# **Urban Design Framework**

## **Supplementary Planning Document**

### **Draft UDF SPD consultation report**

April 2021

#### **para 3.2 - Designing at density**

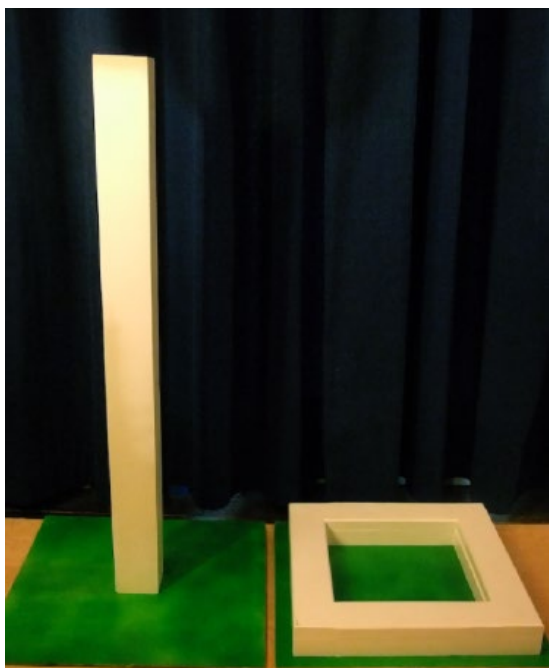
We question the statement at the end of the third paragraph “*However, the greater the density and height of a development...*”

This as expressed, appears to conflate the separate issues of density and height.

Fig 10: Map of existing Strategic Views in Brighton & Hove (UPD-SPD 2020 p14) with proposed Surrenden Road strategic view marked by blue triangles.

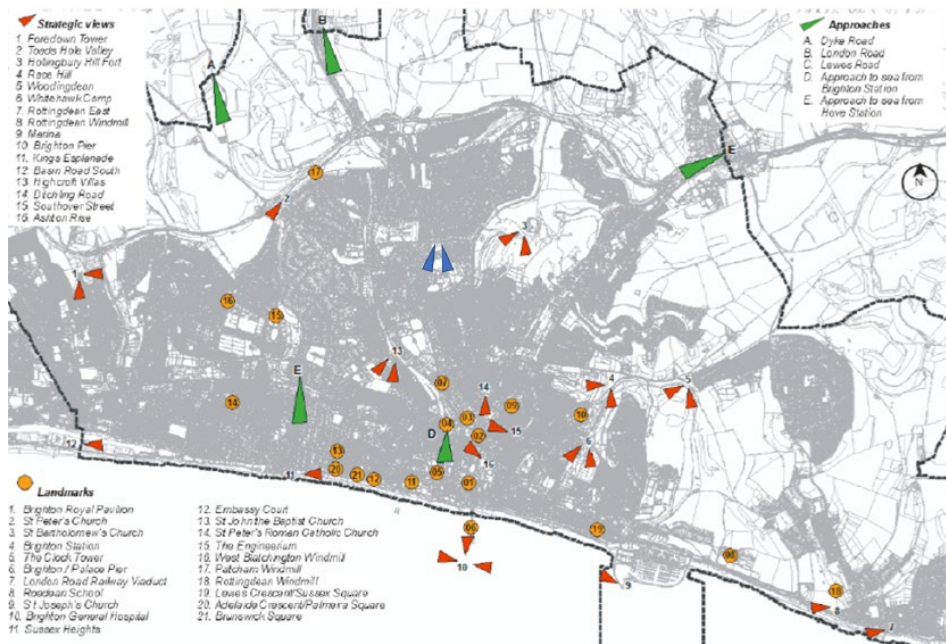
We request that the much-loved wide panoramic view along the northern section of Surrenden Road which runs east-west be classified as a 'strategic view' and be included in the list of strategic views within the UDF-SPD. The view meets all the criteria for a 'Strategic View' as defined within the Urban Design Framework – Supplementary Planning Document. We have submitted a document providing the evidence in support of this request by email.

Surrenden Road serves as a primary route into the city and the main link for traffic entering on Ditchling Road to London Road and onwards to Hove and the west. Therefore, this view gives unique and very striking first impressions of wide space and the urban topography for people initially arriving into the city from that direction. As Figure 10 clearly shows (with the two blue triangles) the addition of this view with its central position, as a strategic view would fill a gap in the spread of strategic views across and around the city.
